revision:	date:	note:
P01	20190425	planning submission
P02	20210113	section 73 application

1.0 Proposed Changes to Condition 2

1.0 The Proposal

1.0 Proposed Changes to Condition 2 Bow Lane Elevation Comparison

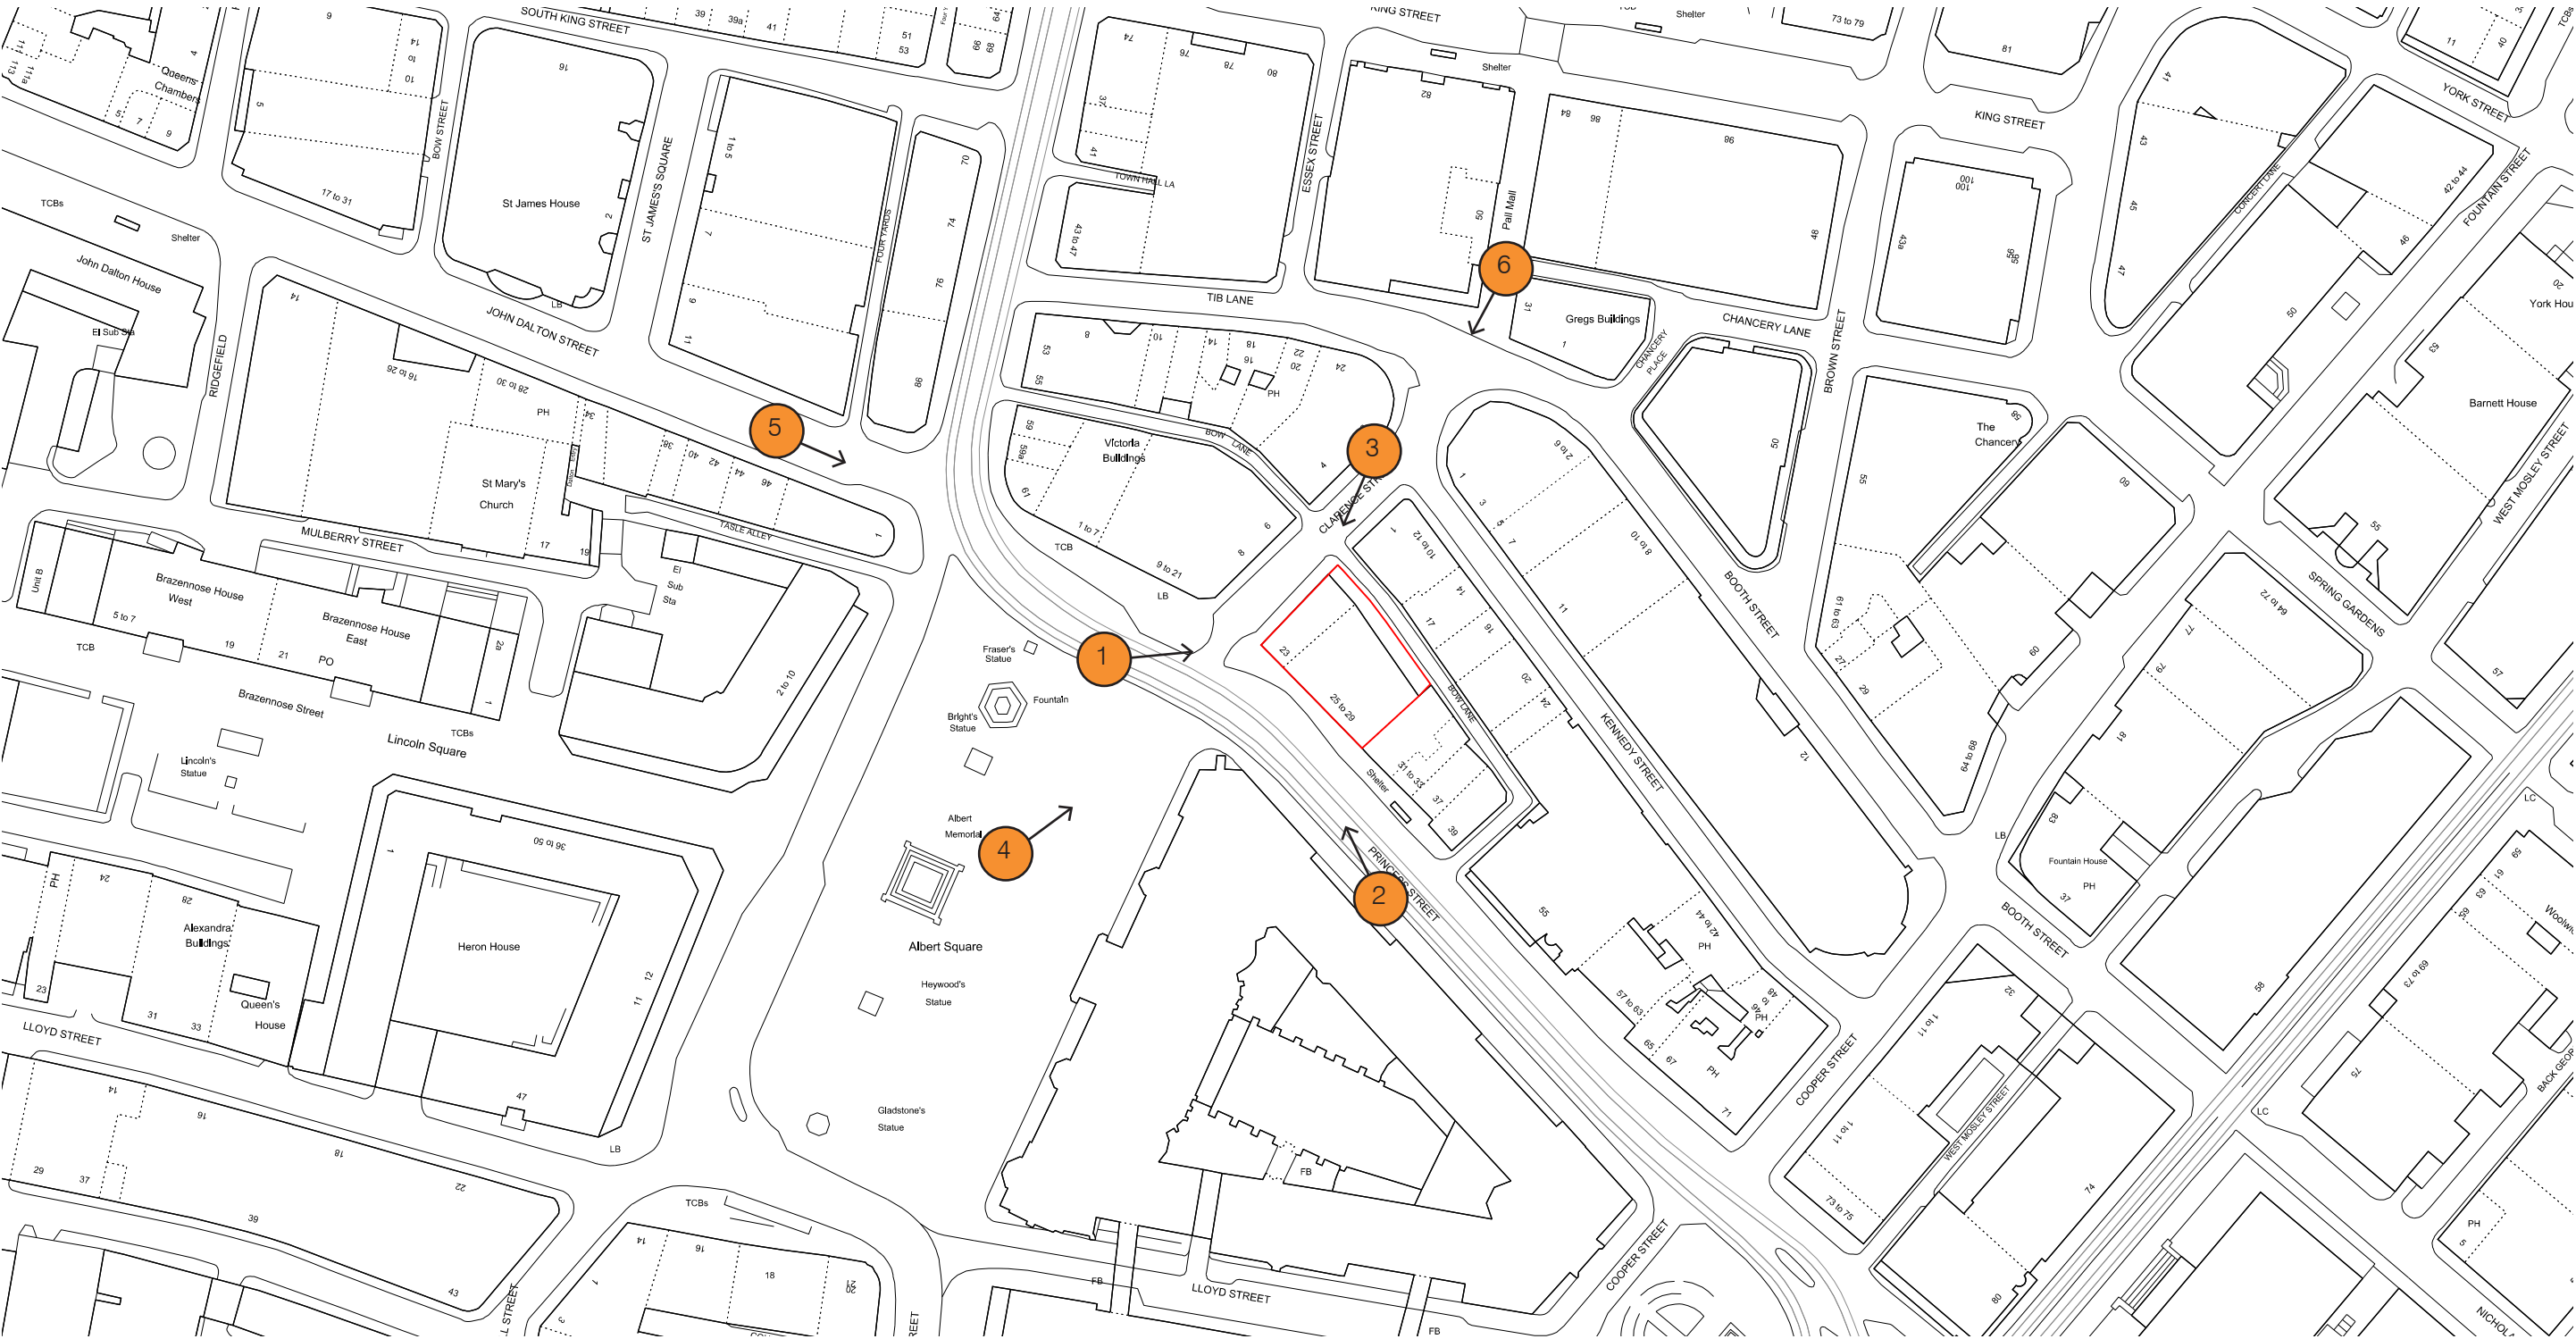
1.5.1 Variation of window size to ground floor window on Bow Lane

- 1.5.2 Due to detailed design development, it has been proposed to amend the large window into two asymmetrical windows with an infill of new stone cladding.
- 1.5.3 It is considered that this doesn't have a detrimental effect on the architectural appearance of the building.
